## ADDENDUM NUMBER 02

Project	LIPSEY'S	Date	03.17.2026
Project Location	HIGHLAND ROAD, ST. GEORGE, LA	Architect's Project Number	24.154
Owner/Client	LIPSEY'S		
To	ARKELE CONSTRUCTORS	Attention	NICK ZAEFF
<p>This Addendum will become part of the Contract Documents. The Contractor shall promptly inform subcontractors and all others performing or supplying any of the Work of all relevant contents of this Addendum. In case of conflicting provisions with previous addenda or communications, provisions in this Addendum supersede only those conflicting issues. It is the responsibility of the Contractor to notify all subcontractors from whom it accepts bids of all changes in the drawings and specifications covering this project. Receipt shall be acknowledged by inserting the addendum number and its date in the bid form.</p>			
Distribution	ARKELE, OWNER, CONSULTANTS		
Prepared by	Lori Prochaska	Date	03.17.2026
Instructions / Description / References / Dates

ARKEL CONSTRUCTORS LLC Request for Information	Bid RFI No: 1 Date Submitted:
<b>Project:</b> Lipsey's New Headquarters <b>A/E:</b> Ritter Maher <b>Contractor:</b> Arkel Constructors

# LIPSEY'S NEW HEADQUARTERS

**GRADING & DRAINAGE PLAN**  
**C3.01**

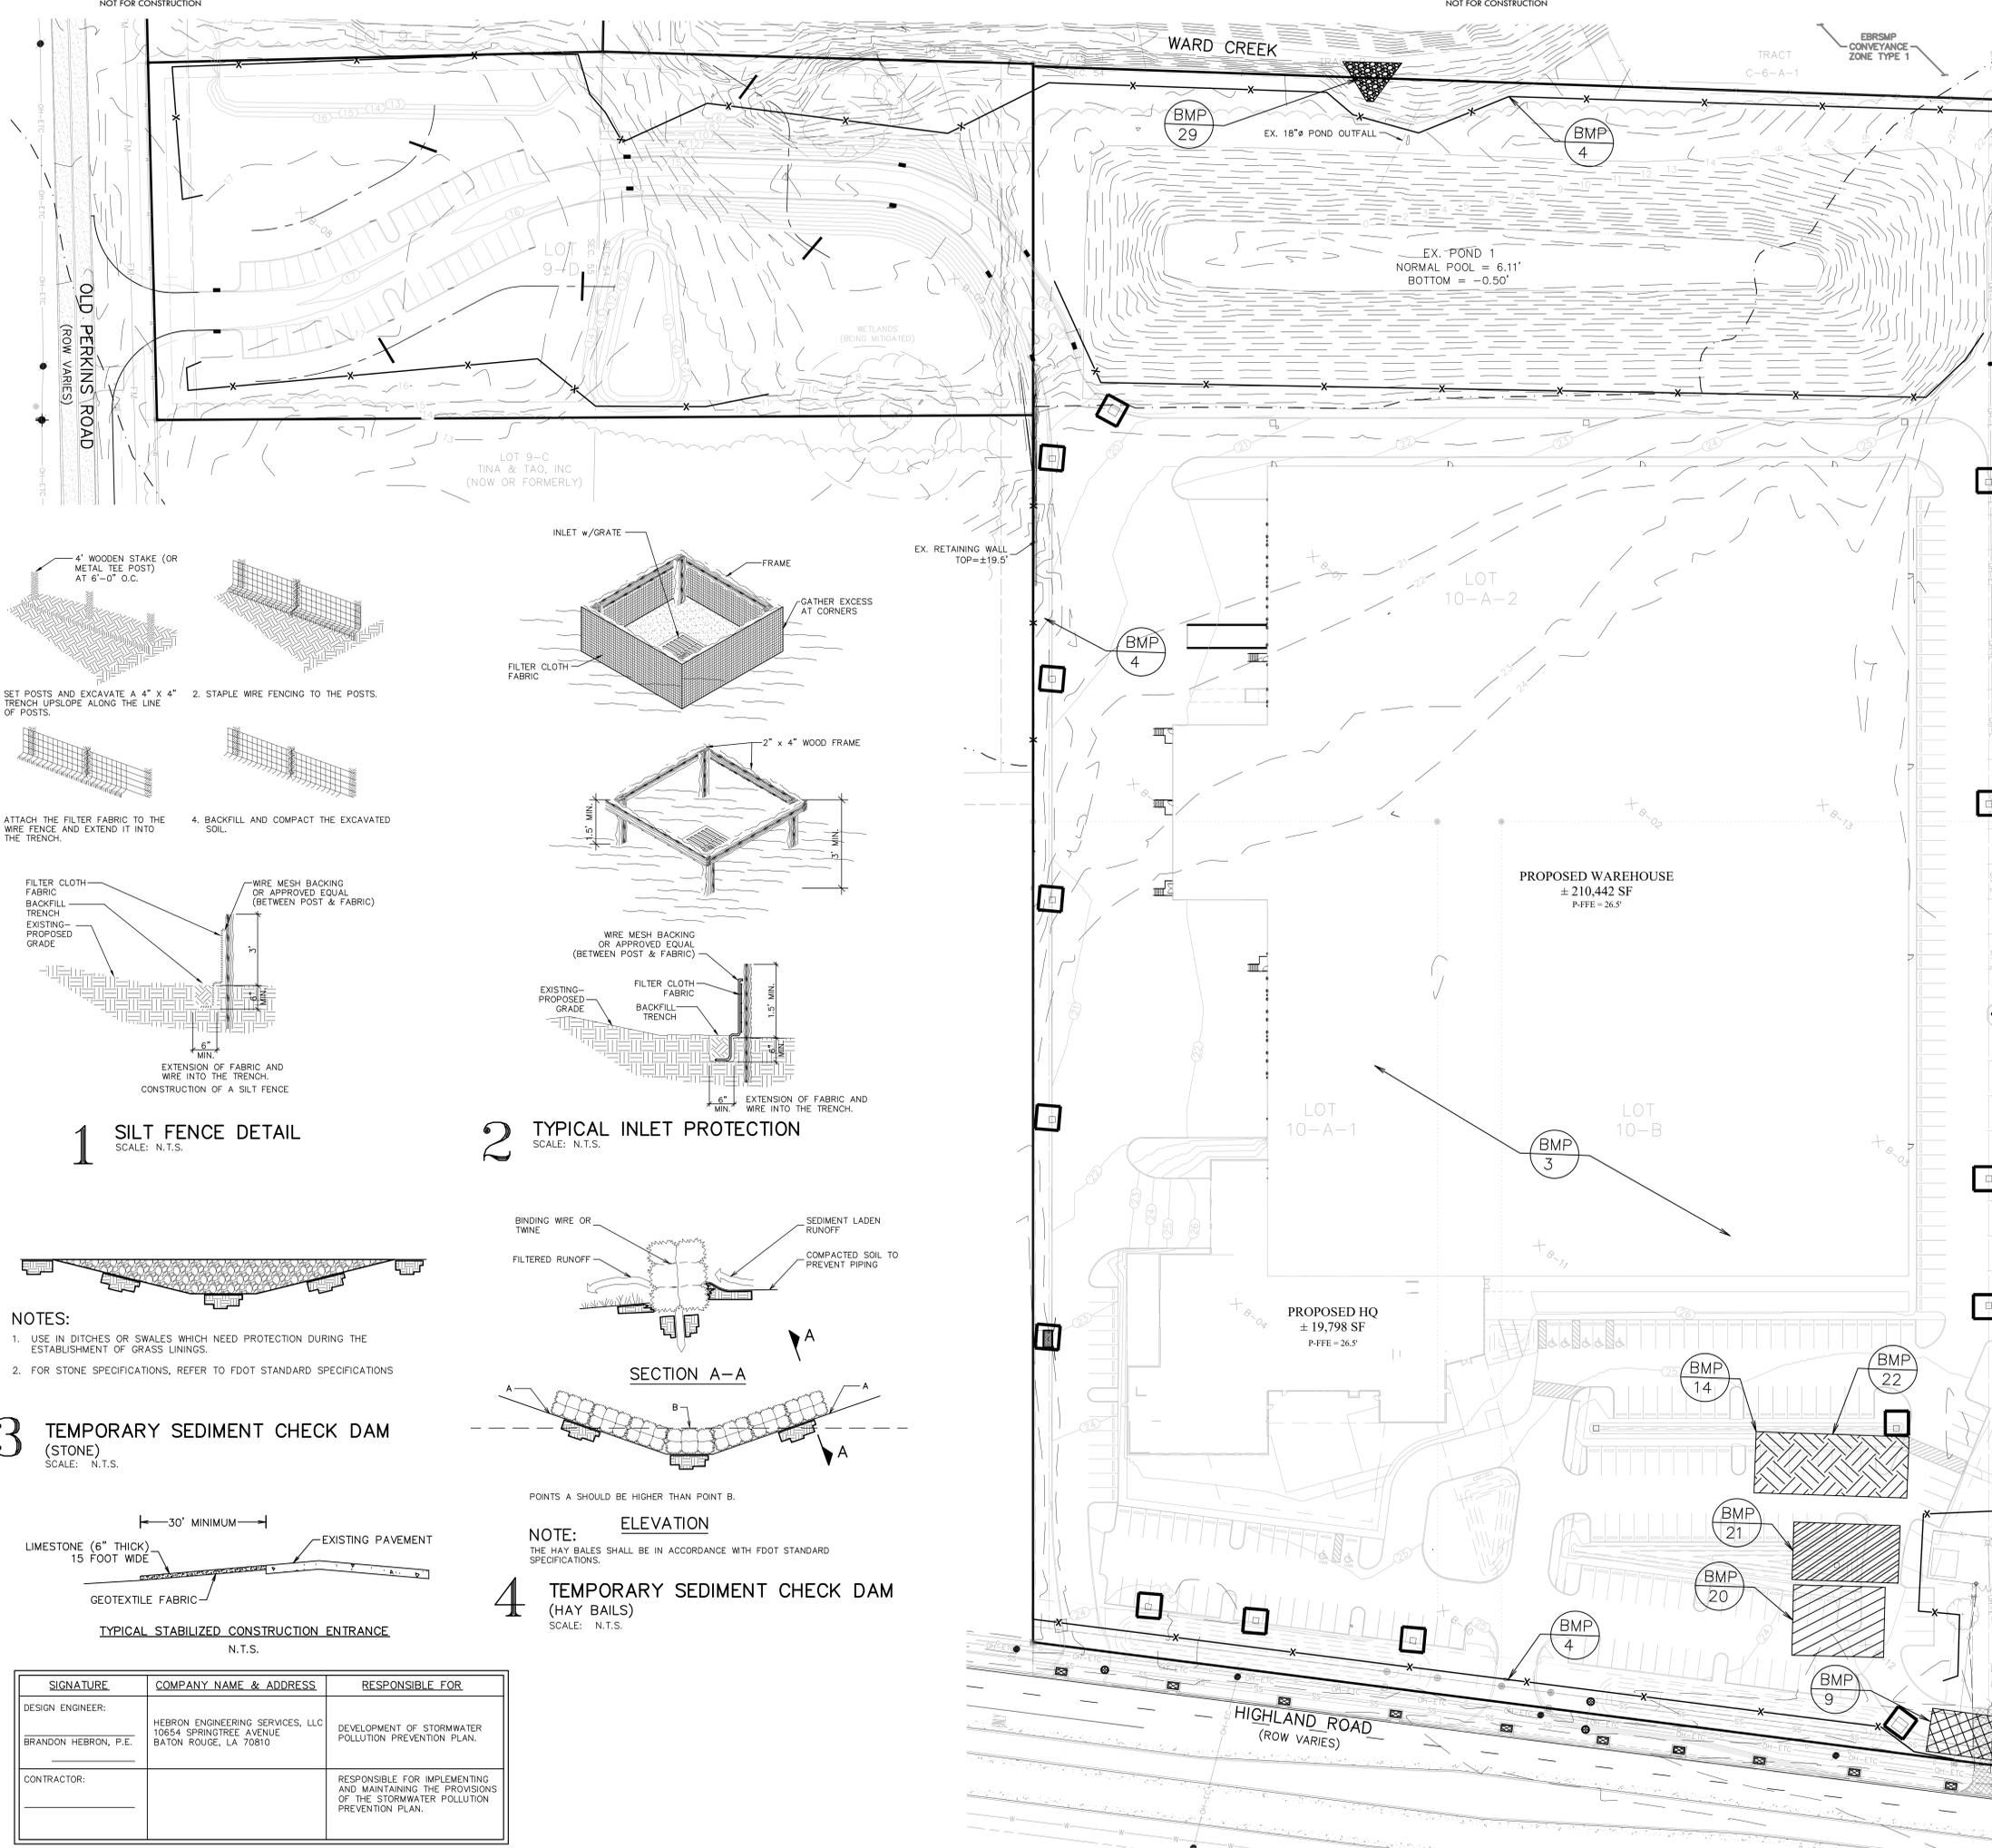
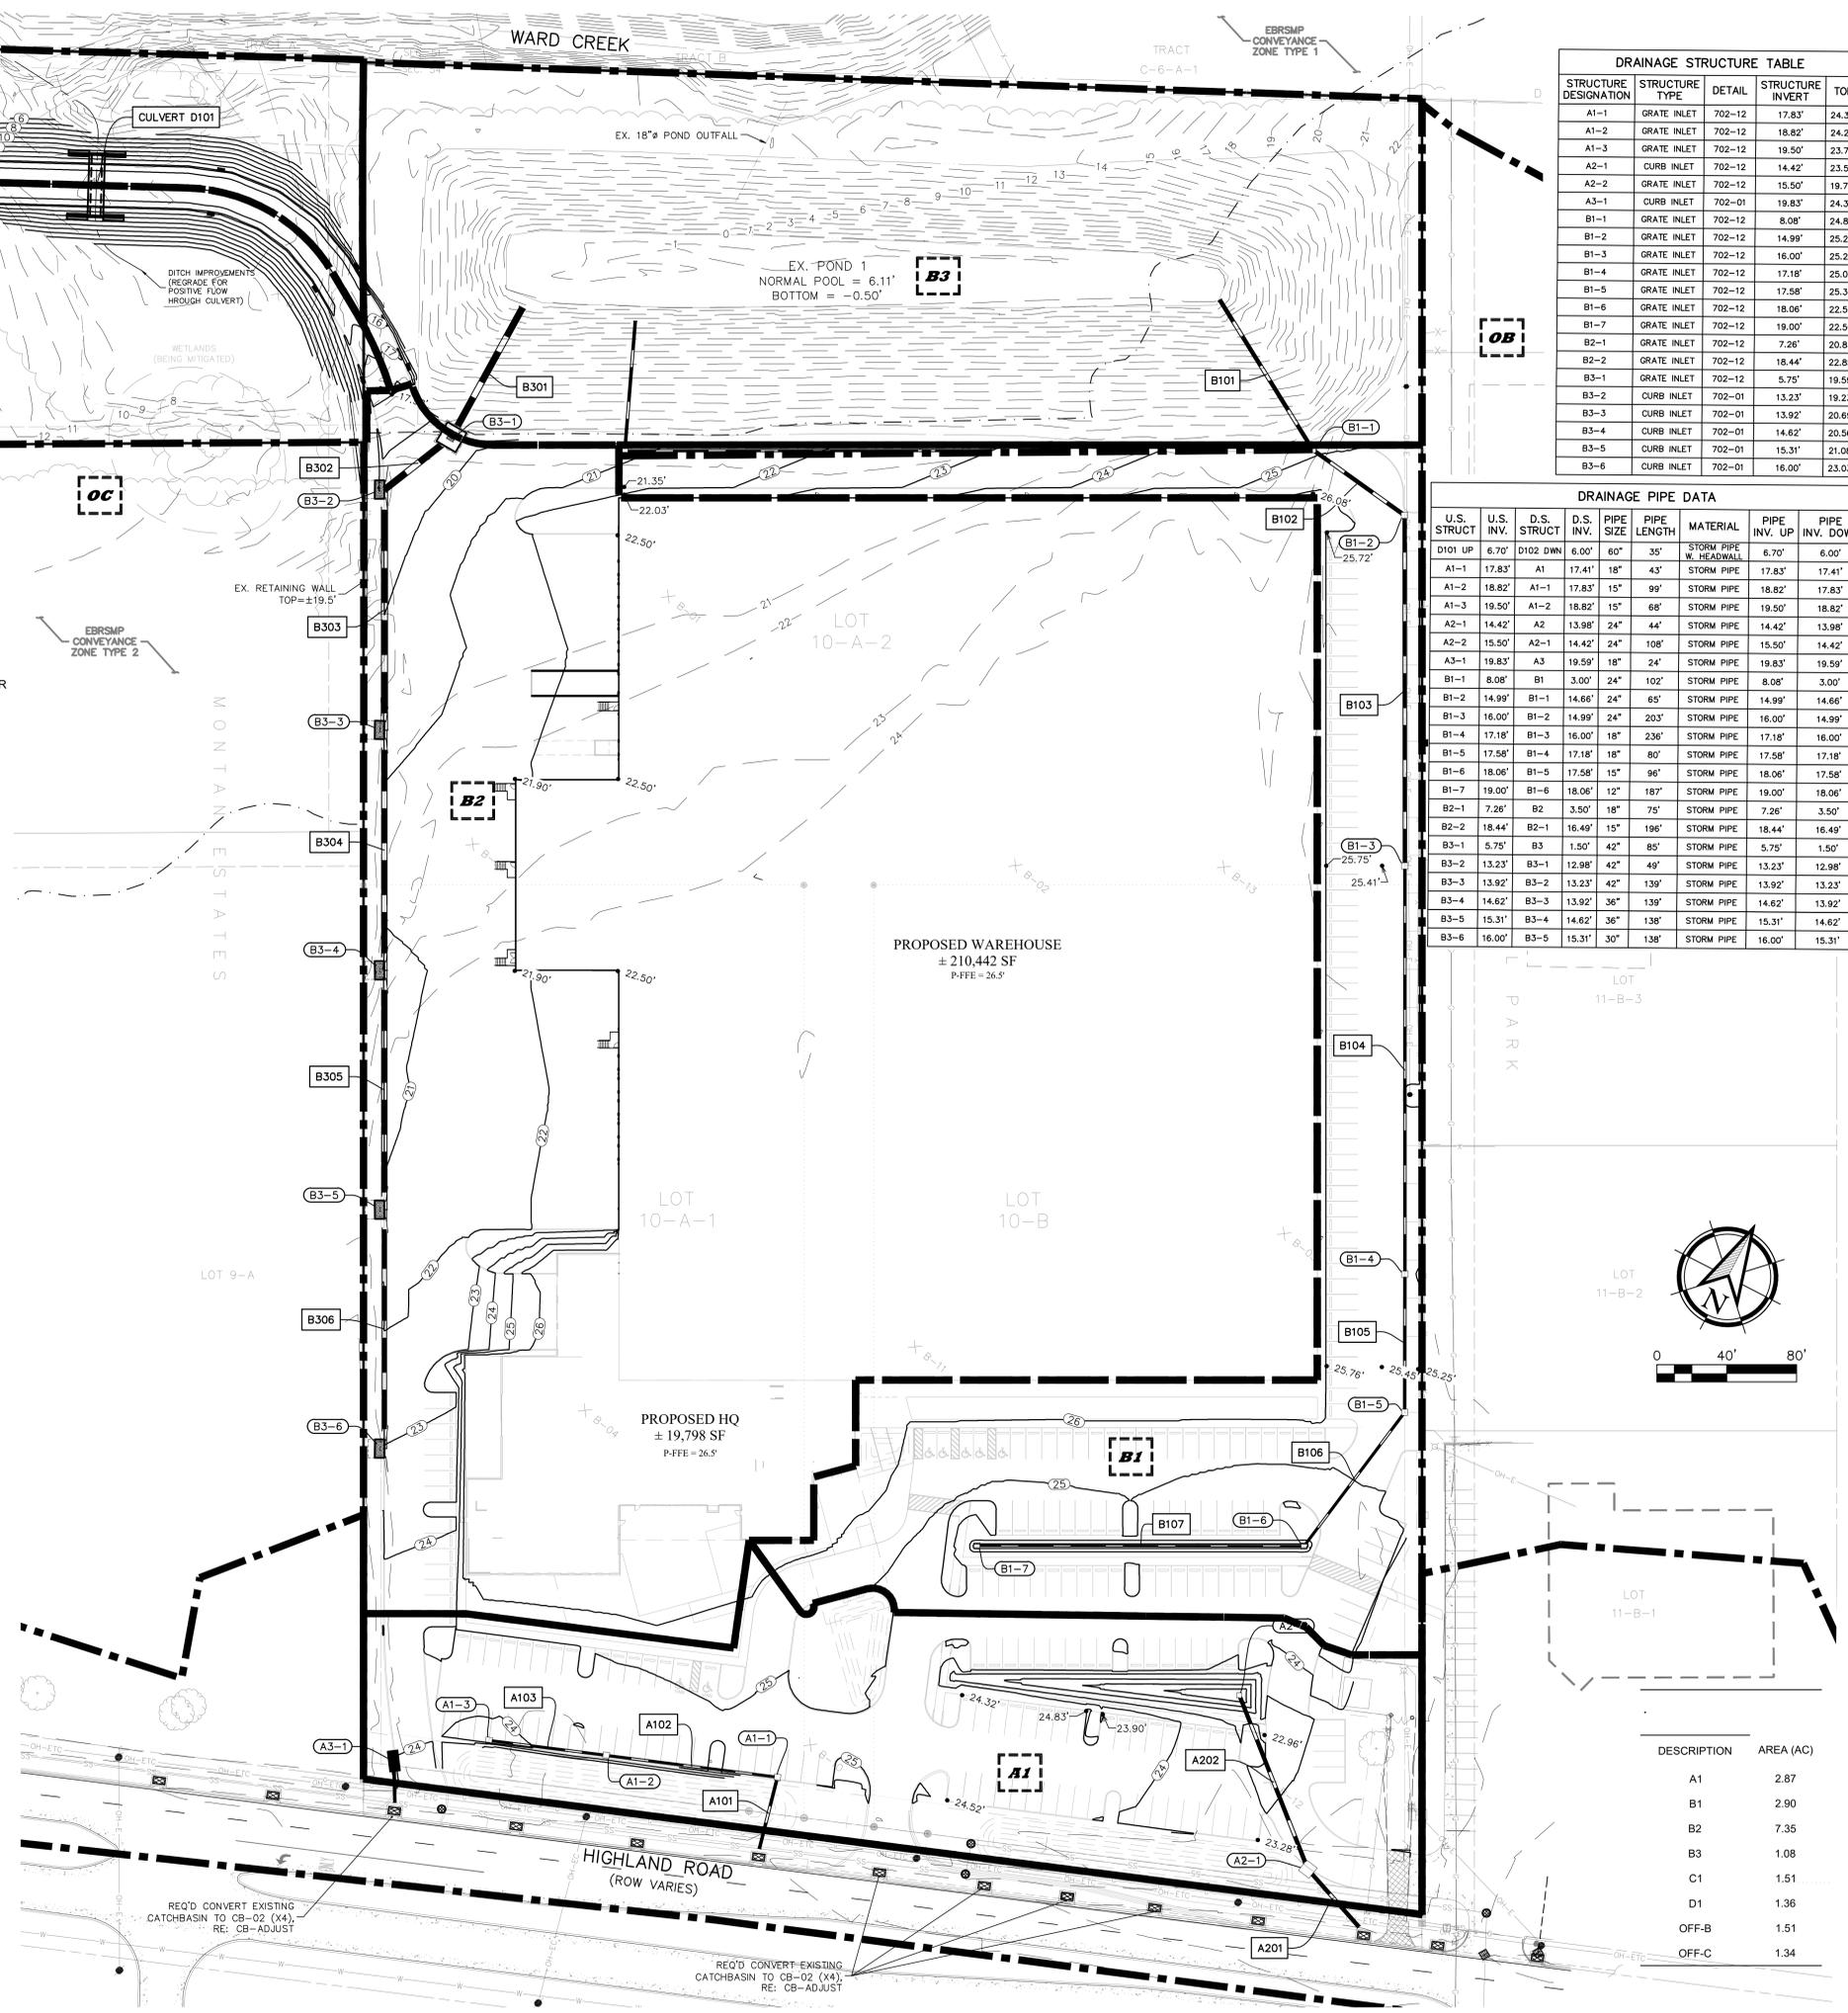
G0.00.V1 TITLE SHEET  
 C3.01 GRADING & DRAINAGE PLAN

SHEET NUMBER		DATE	
DESIGN	CHECK	REVIEW	DATE
PRECAST CATCH BASINS AND MANHOLES			
PC-01			
CS-19

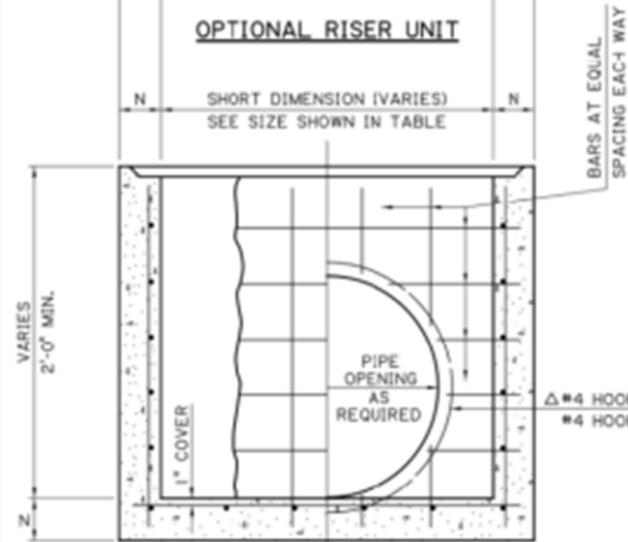
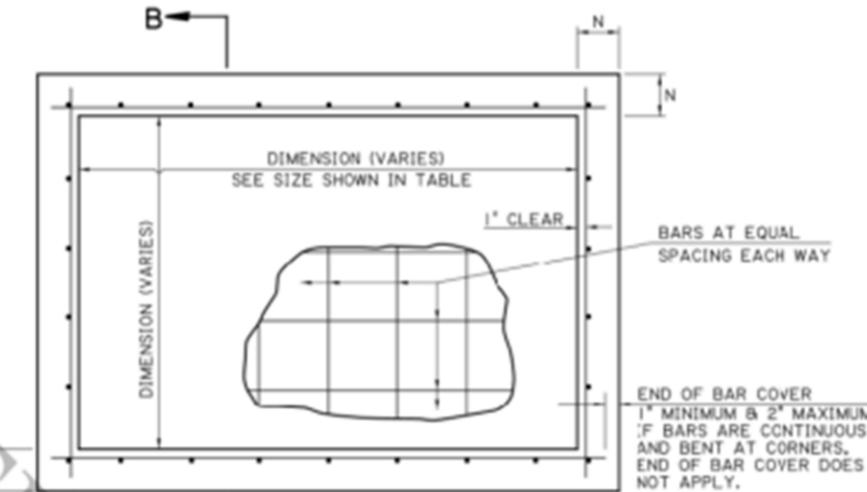
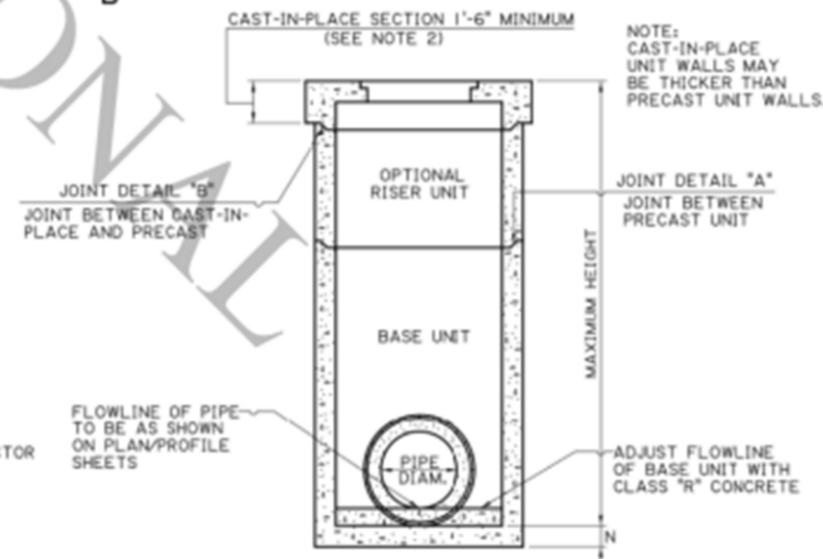
9				Can we use pre-cast concrete inlets?	<p>Precast inlets are acceptable for this project. Contractor may furnish either cast-in-place inlets or precast inlets in accordance with LADOTD Standard Specifications and Standard Plans, subject to the submittal and approval requirements in accordance with the below.</p> <p>(-) LADOTD Standard Specifications: Section 701 (Culverts &amp; Storm Drains) and Section 702 (Manholes, Junction Boxes, Catch Basins, and Endwalls).</p> <p>(-) LADOTD Standard Plans: PC-01 – Precast Catch Basins and Manholes, and applicable gutter/inlet standard plan indexes.</p> <p>NOTE: Drainage structures shall be listed on the LaDOTD Qualified Products List (QPL), or the East Baton Rouge Parish QPL / Standard Products List,</p>
10				Will an erosion plan be provided?	Yes, Please see the added sheet, C7.0
